September 15, 2010

Attn: Document Control Desk
Ron Linton
Project Manager
Uranium Recovery Licensing Branch
Division of Waste Management and
Environmental Protection
Office of Federal and State Materials and
Environmental Management Programs
U.S. Nuclear Regulatory Commission
Two White Flint North, MS T8F5
11545 Rockville Pike
Rockville, MD 20852

Re: Text Revisions to the Open Issues to the Safety Evaluation Report for the Nichols Ranch ISR
Project License Application (TAC J00553, Docket No 040-09067)

FIGURE 2-21b. WATER-LEVEL WATER IN THE H SAND AQUIFER AT THE HANK UNIT, 2009, IN FT

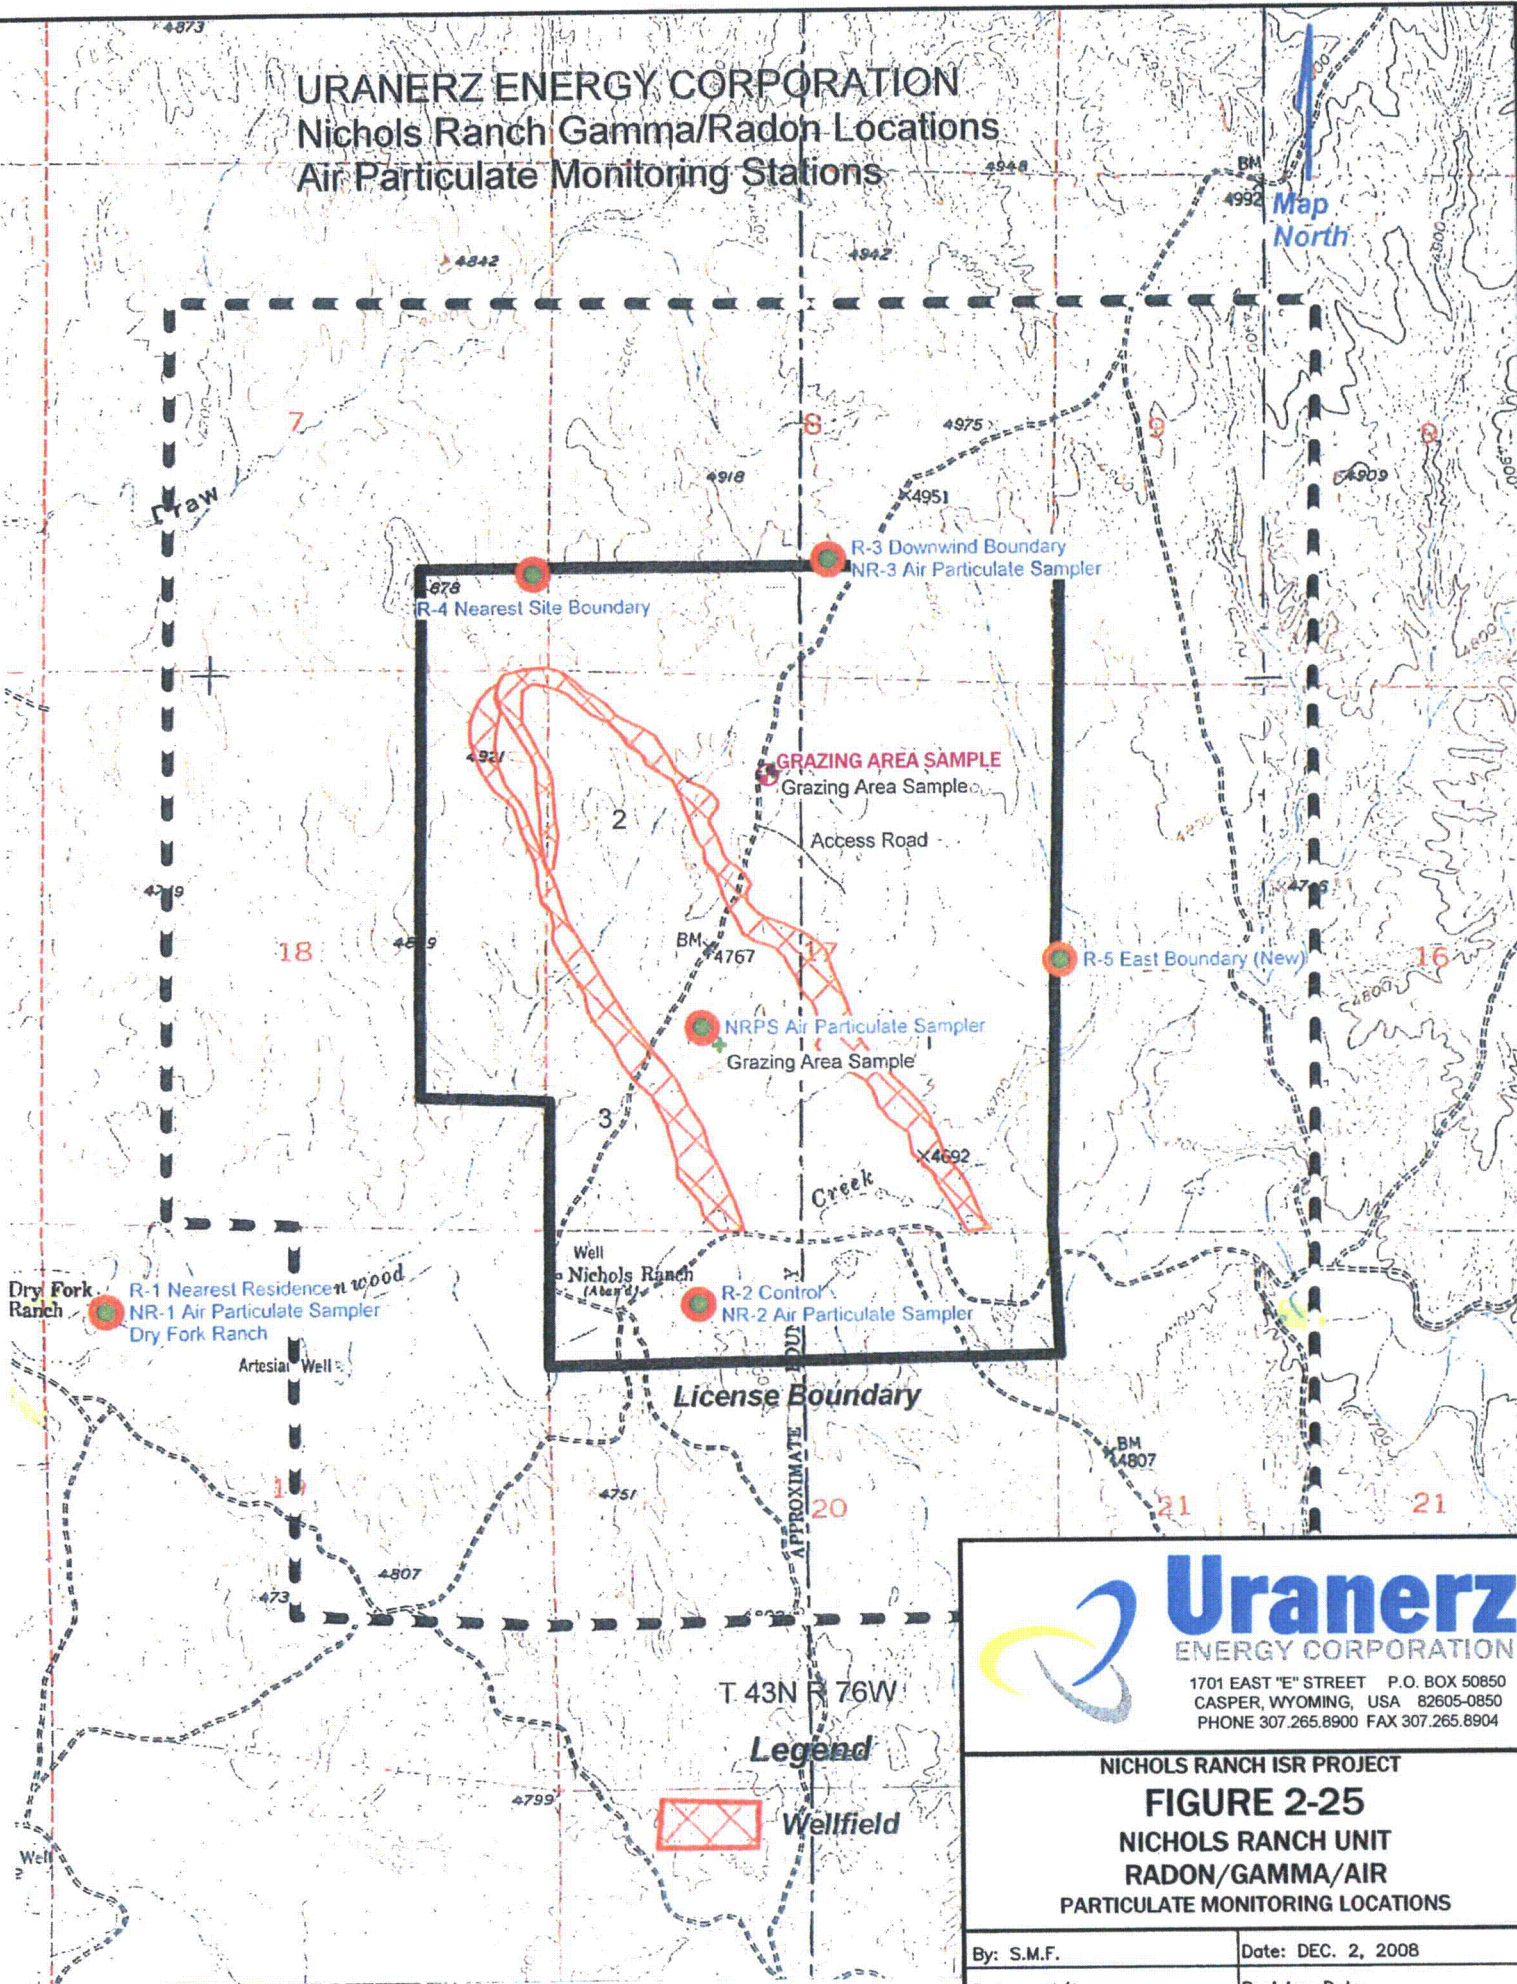
2.4.8	Y	Figure 2-21b of the TR Volume I
2.4.9	Y	Addendum D6C of Volume VI, Appendix D6 Addendum 3C (Need to add in numerical modeling as 3B & 3C), Section 7.2.3.1 & 7.2.3.2

NICHOLS RANCH ISR PROJECT
FIGURE 3-2
HANK UNIT
SITE FACILITY DIAGRAM

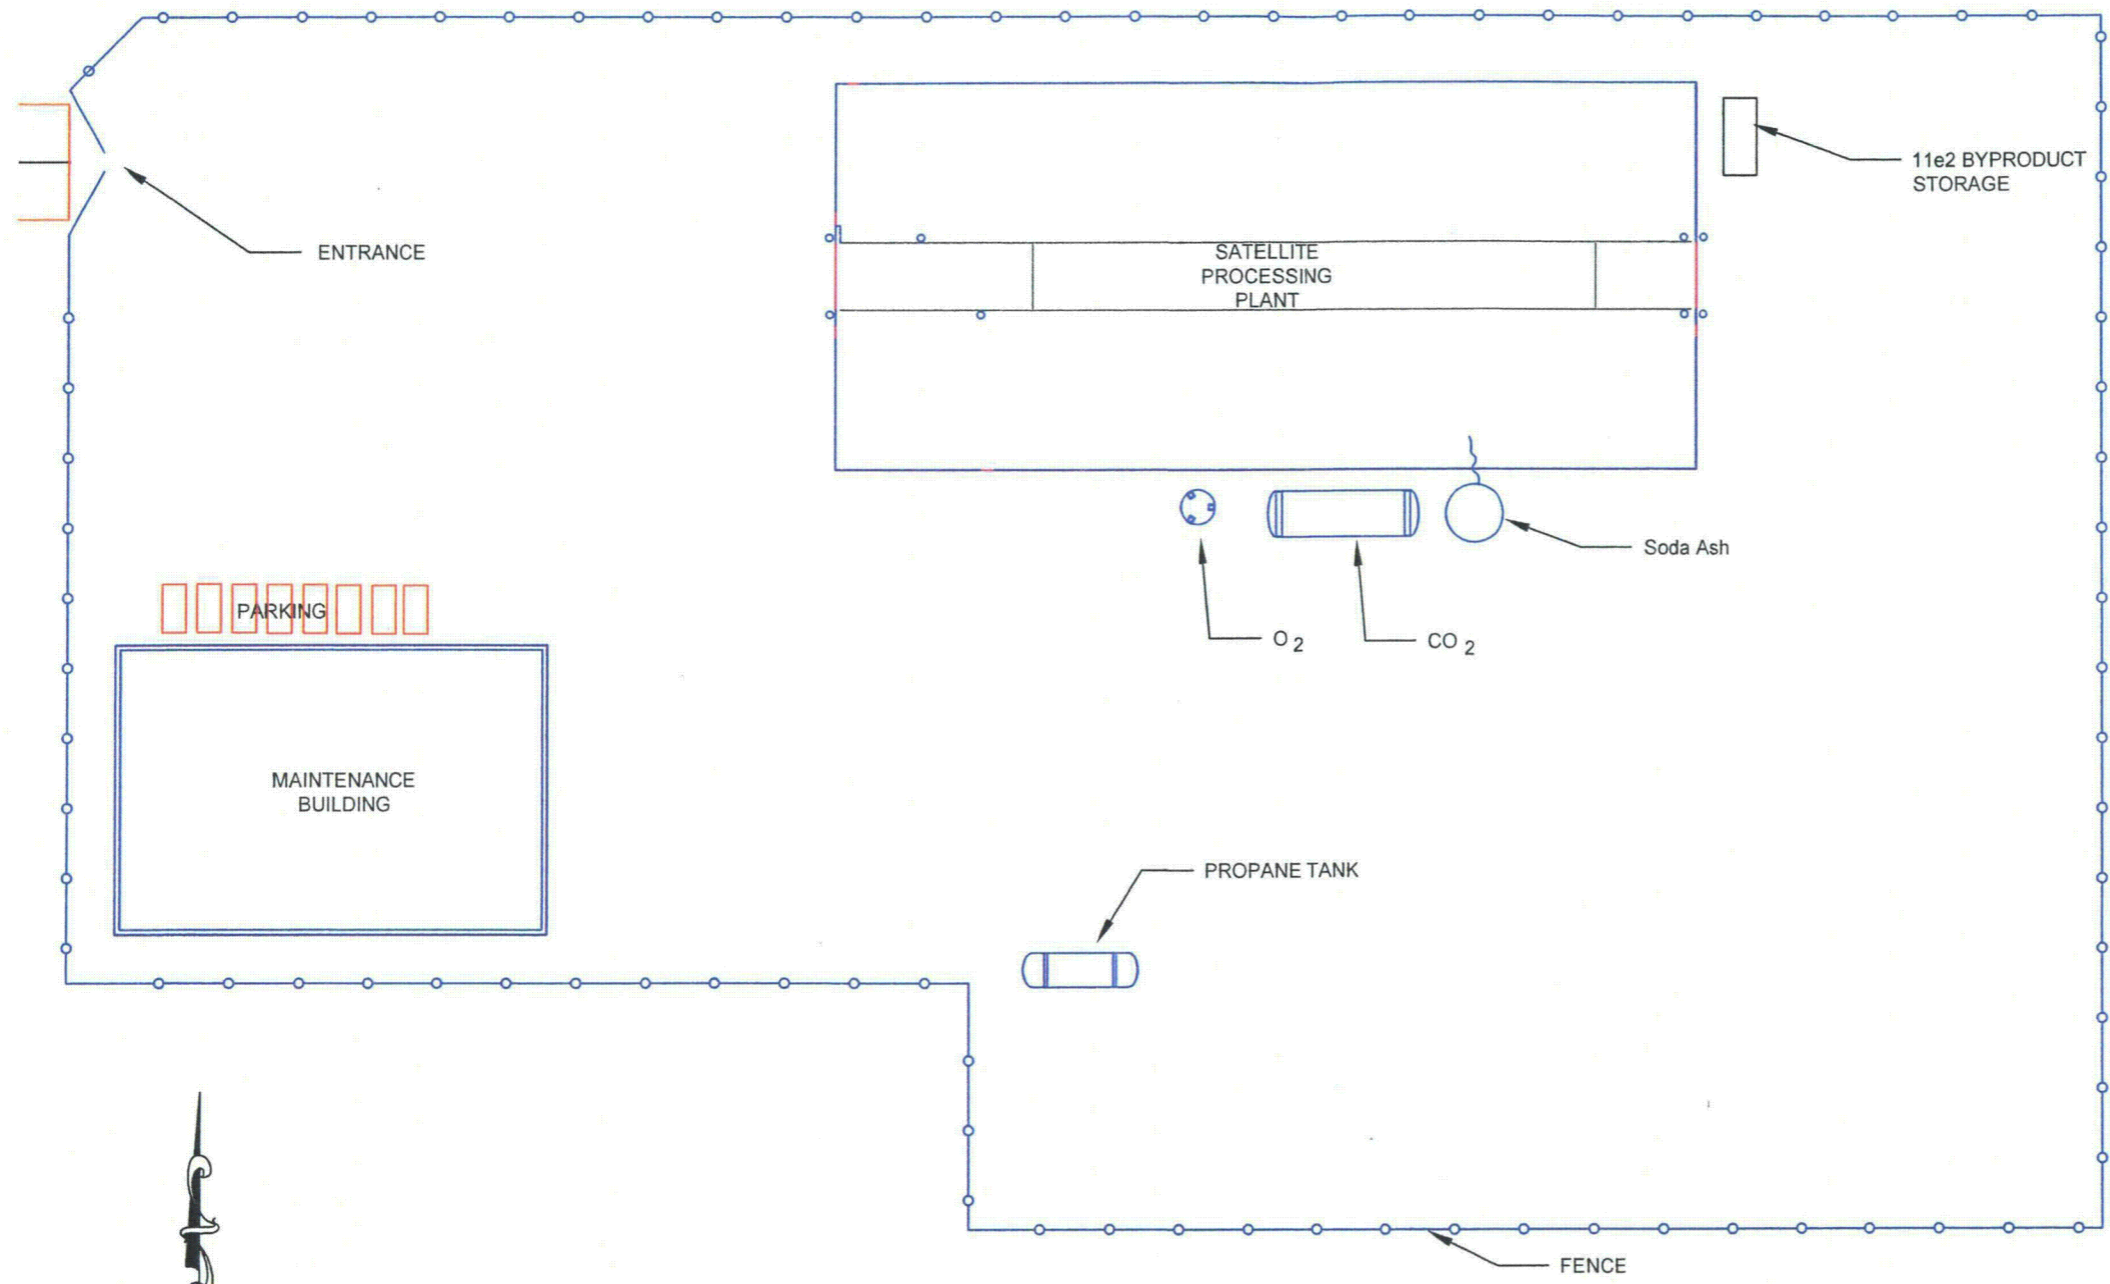
7.0.3	Y	Section 7.5.3.1
7.0.4	Y	Figure 3-1 and Figure 3-2
7.0.5	Y	Section 7.5
